ITS DISCUSSION OF DIFFERENCES

ITS Section 3.7: Plant Systems

Figure 3.7.1-1 (page 1 of 1)
Reduced Power and Nuclear Overpower Trip Setpoint
versus OPERABLE Main Steam Safety Valves

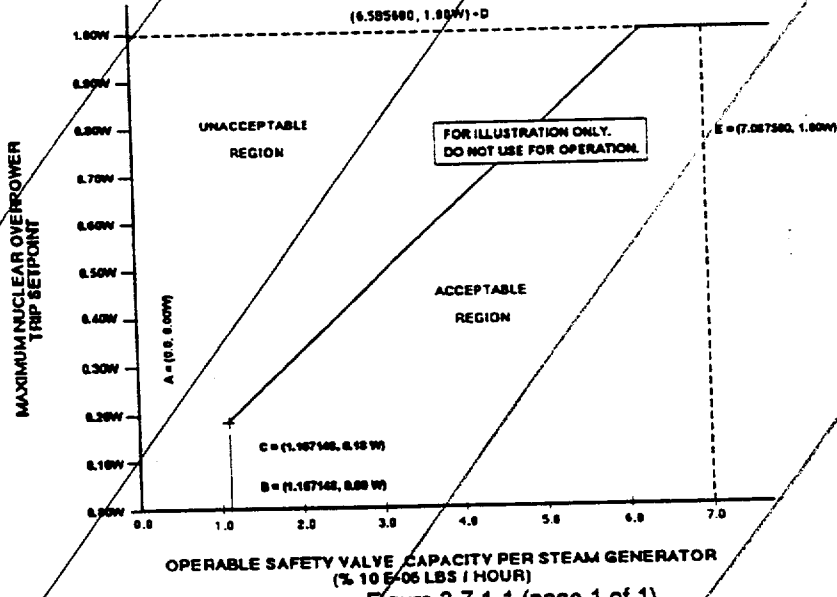
- 1 NUREG-3.7.1 - The main steam safety valves (MSSV) Specification is reformatted to omit the table of specific lift setpoints and to replace the figure for determining the allowable power level and trip settings with predetermined values. The specific lift setpoints are currently required to be tested by current Technical Specification (CTS) Table 4.1-2, item 4. However, the CTS does not contain the specific setpoints. These setpoints are currently identified in the Inservice Testing (IST) Program and are adequately controlled therein under the design change and procedural control programs which include evaluations of changes in accordance with 10 CFR 50.59. Control of these setpoints is proposed to be retained in these programs. A minor editorial change is proposed to clarify that the 1% tolerance is only applicable to the "as-left" settings. The NUREG figure for determining the allowable nuclear overpower-high trip setpoint is provided for units which have MSSVs with different relief capacities. Since it would not be possible to predetermine which valves would be inoperable for the condition, a figure is not provided to calculate the required trip setpoint. However, all MSSVs at ANO-1 are of the same relieving capacity. Therefore, the allowable setpoint for the trip function can be predetermined based on the minimum number of OPERABLE valves per steam generator. This evaluation has been done and provided in a new Table 3.7.1-1, rather than by a figure, for the operators convenience. Also, the wording of Required Action A.1 is revised since the terminology of "reduced power requirement" from the figure is not used in the new Table. The proposed wording is consistent with the wording of Required Action A.2.

45
Figure 3.7. 15-1 (page 1 of 1)
Burnup versus Enrichment Curve for
Spent Fuel Storage Racks

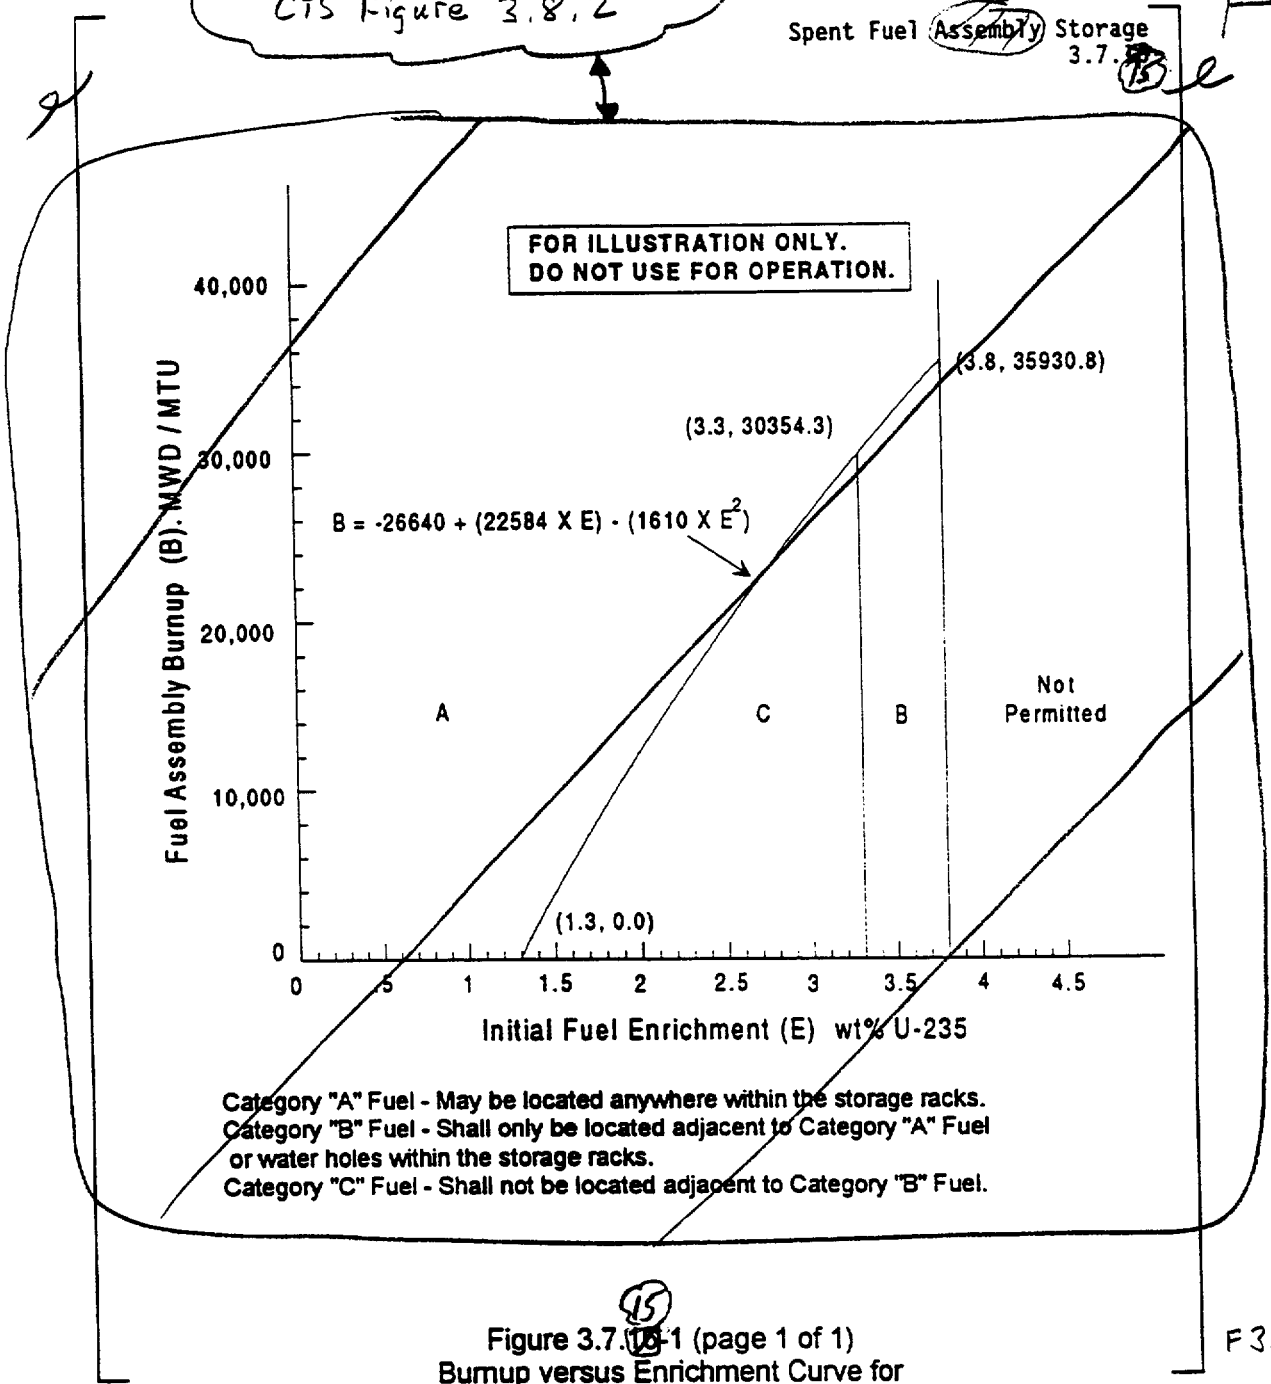
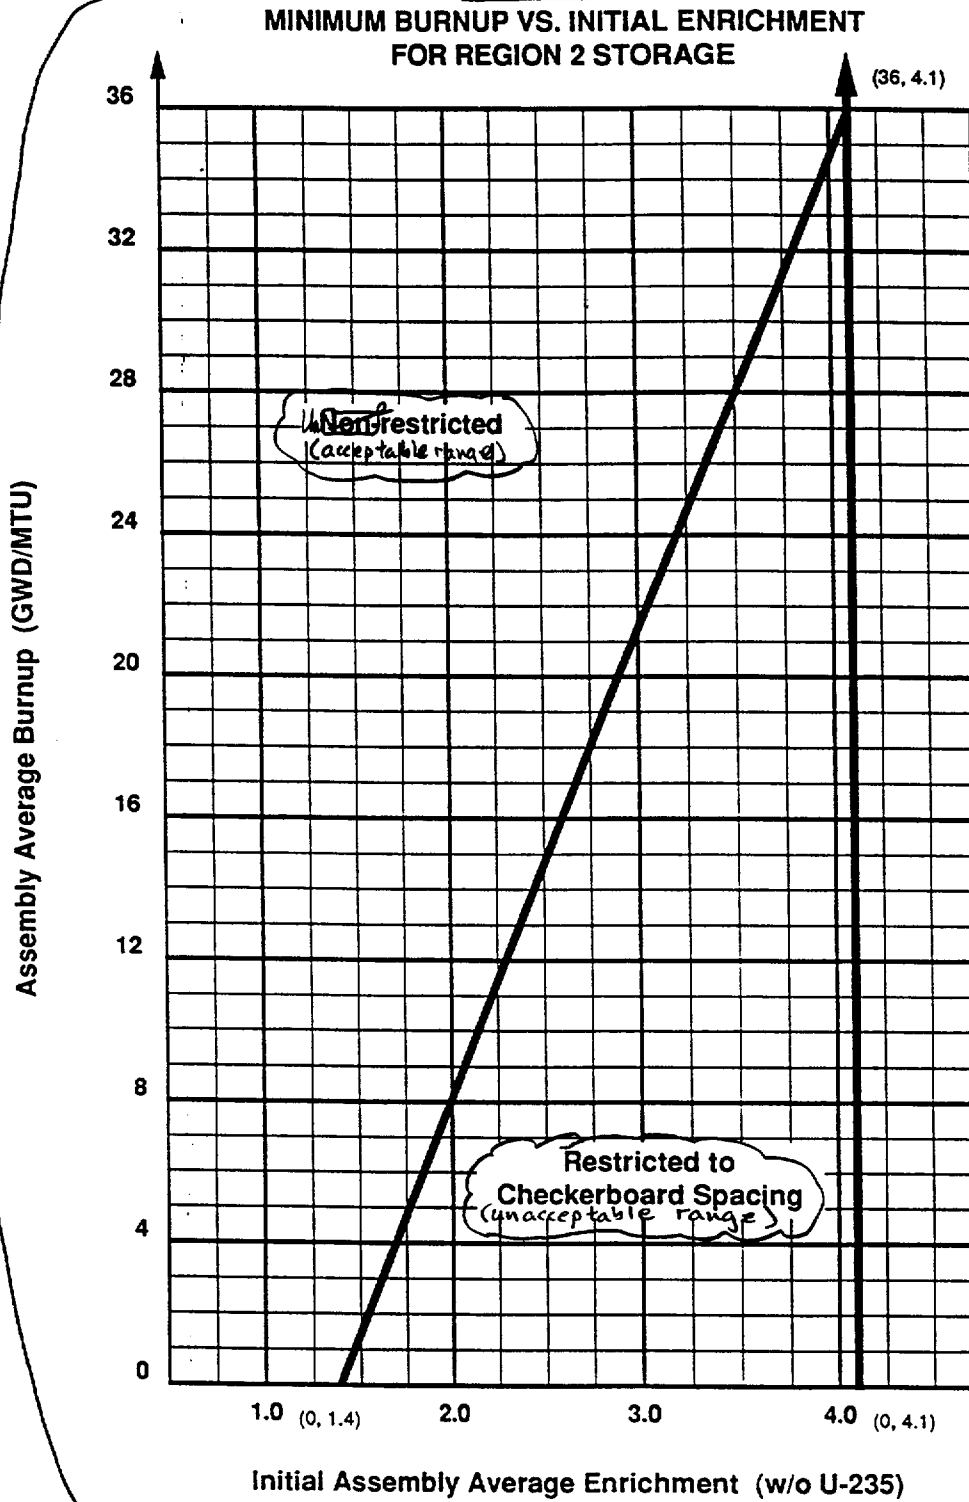
Replace with AND-1
CTS Figure 3.8.2

Figure 3.7.18-1 (page 1 of 1)
Maximum Allowable Steam Generator Level

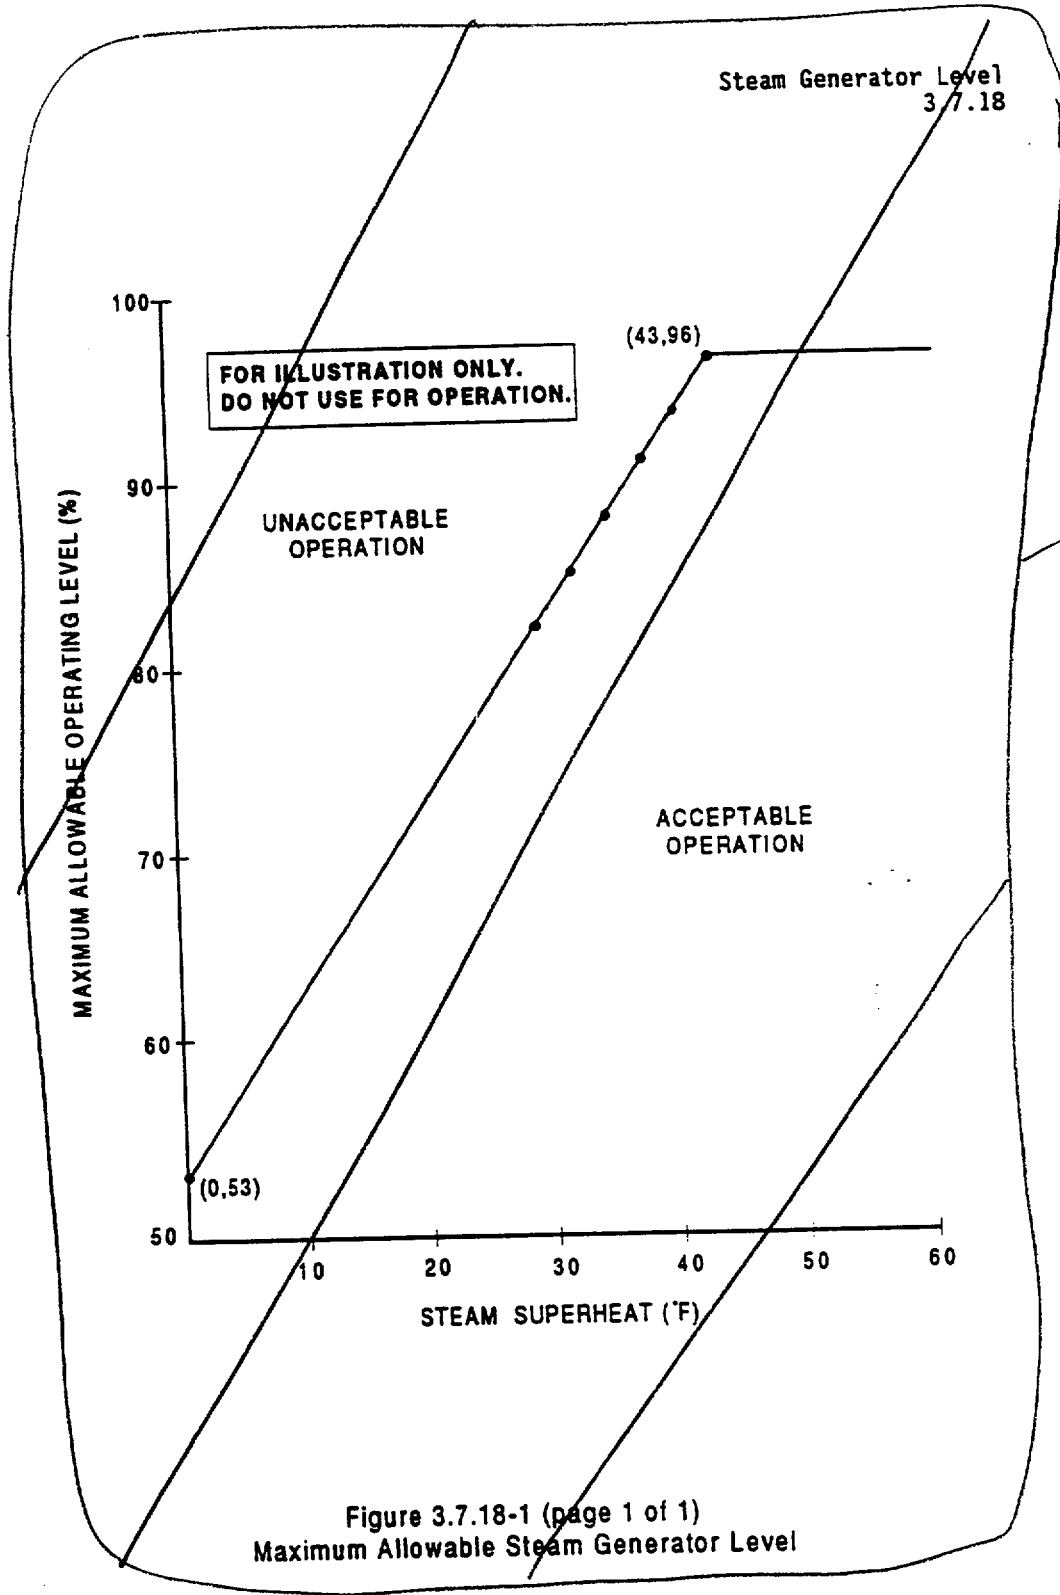
38
